Re: Commerce Drive Solar – Site Plan Application
Tax Map 102 - Lot 9 & 402

Re: Response to Comments for Site Plan Review Application

This project has completed a conceptual review by the City of Franklin planning board on March 27, 2024. Comments from planning staff were provided based on the conceptual submittal. Responses can be seen below in blue font.

TYPICAL WOOD POST AND KNOT WIRE FENCE
NOT TO SCALE

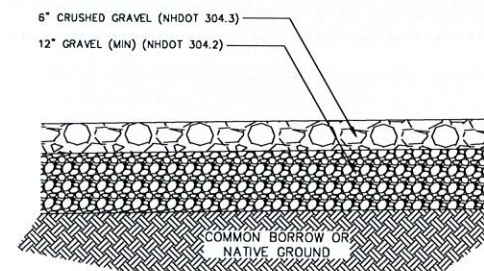
a) Fencing has been proposed, thank you. Please provide a detail of said fencing.

The details of the proposed fencing can be seen on sheet C-7 as well as in the submitted informational packet.
